# Access Compliance Report

## Public Rights-of-Way

| Intersection ID: 30500                  | Main Street: ORCHARD_GRASS_CT | Cross Street: YOUNG_FAWN_CT             | Location: NE           |
| ADA ID: D2F7D365E12A                    | Ramp Type: PerpDiag           | Initial Pass/Fail: Fail                 | Overall Compliance: No |

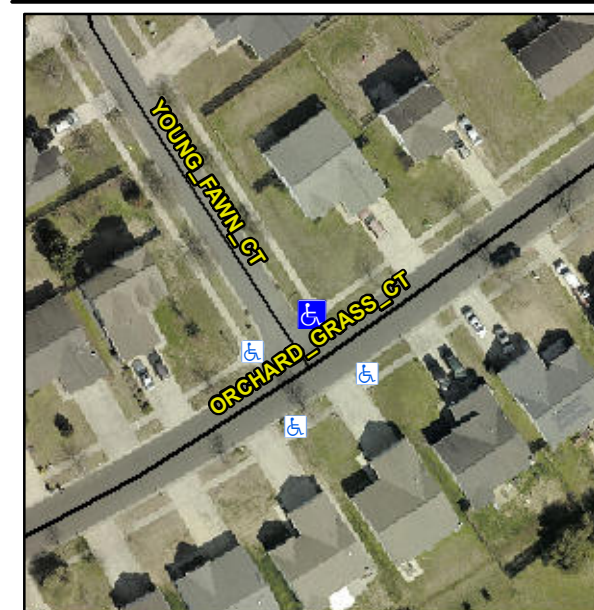
| Severity Score: 8.75                    |                               |   |                        |

**R304.5.1**

| Compliance | Description           | Data  | Compliance | Description                 | Data  |
|------------|-----------------------|-------|------------|-----------------------------|-------|
| No         | Ramp Width (in)       | 38.0  | Yes        | Ramp XSlope (%)             | 0.1   |

**Remove & Replace Curb Ramp With Two New Directional Ramps or Equivalent.**
